# UNITED STATES PATENT AND TRADEMARK OFFICE

APPLICATION NO.	FILING DATE	FIRST NAMED INVENTOR	ATTORNEY DOCKET NO.	CONFIRMATION NO.
10/624,542	07/23/2003	Man Chi Li	402725	7495
23548	7590	07/12/2004	EXAMINER	
LEYDIG VOIT & MAYER, LTD 700 THIRTEENTH ST. NW SUITE 300 WASHINGTON, DC 20005-3960			KLAUS, LISA NHUNG	
			ART UNIT	PAPER NUMBER
			2832

## Office Action Summary

## **DETAILED ACTION**

Fig. 1

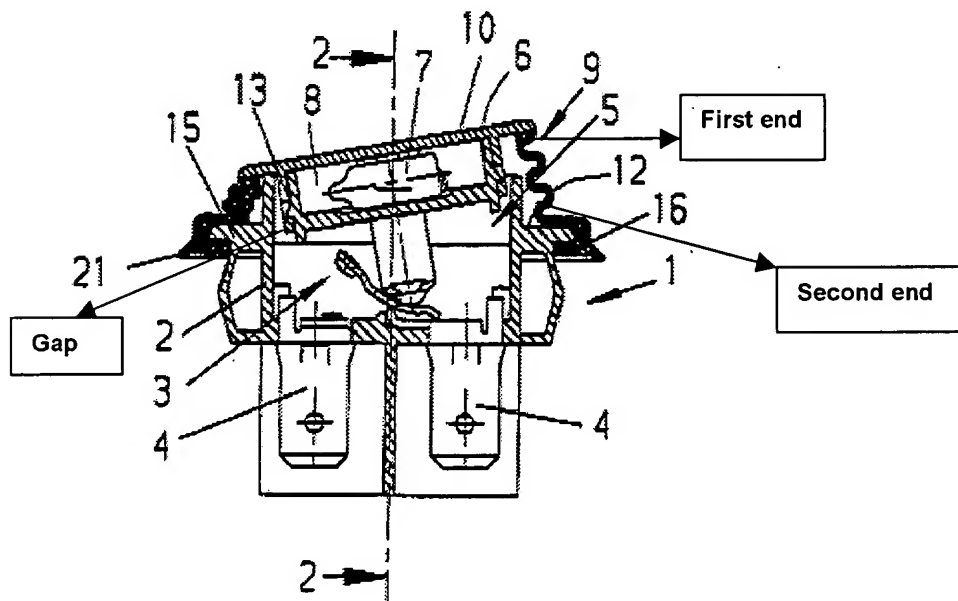
- a housing 2 having an opening 5;
- a plurality of fixed contacts 4 located in the housing for movement;
- at least one moving contact 3 movable by the switching member (see the attachment) for movement to come into contact with and out of contact from the fixed contacts, and

- an actuator 9 disposed in the opening 5 for movement to actuate the switching member (see the attachment) and in turn the moving contact, with a gap (see the attachment) formed between the actuator 9 and the opening 5 that surrounds the actuator 9;

- wherein a resiliently deformable seal 11 and 12 is connected across the opening 5 and the actuator 9 to seal off the gap (see the attachment), thereby avoiding entrance of foreign matter through the gap (see the attachment) into the housing 2;

- the seal 11 and 12 comprises a sleeve having opposite ends connected to the opening 5 and the actuator 9 respectively, a first of the ends (see the attachment), being disposed around the corresponding one of the opening and actuator 9;

Fig. 4

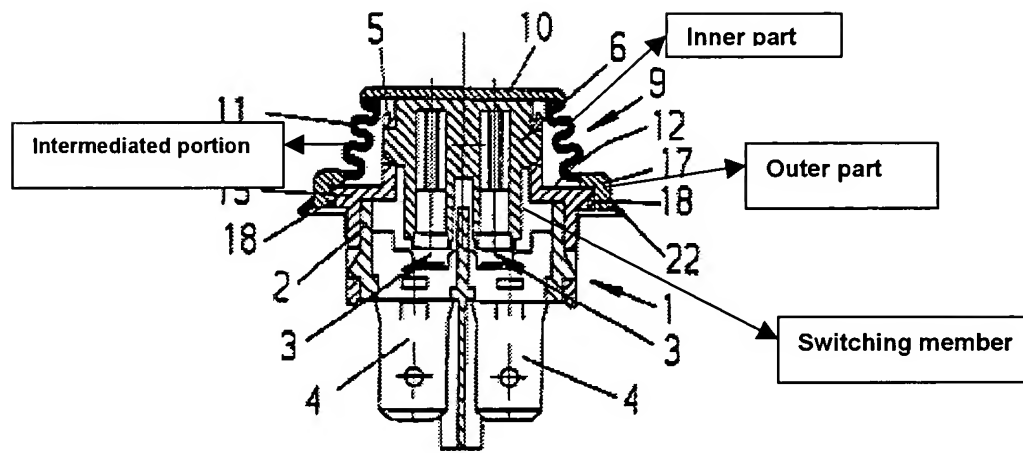
1. The drawings are objected to because the element number 50 in figure 2 is different from figure 4. Corrected drawing sheets are required in reply to the Office action to avoid abandonment of the application. Any amended replacement drawing sheet should include all of the figures appearing on the immediate prior version of the sheet, even if only one figure is being amended. The figure or figure number of an amended drawing should not be labeled as "amended." If a drawing figure is to be canceled, the appropriate figure must be removed from the replacement sheet, and where necessary, the remaining figures must be renumbered and appropriate changes made to the brief description of the several views of the drawings for consistency. Additional replacement sheets may be necessary to show the renumbering of the remaining figures. The replacement sheet(s) should be labeled "Replacement Sheet" in the page header (as per 37 CFR 1.84(c)) so as not to obstruct any portion of the drawing figures. If the changes are not accepted by the examiner, the applicant will be notified and informed of any required corrective action in the next Office action. The objection to the drawings will not be held in abeyance.
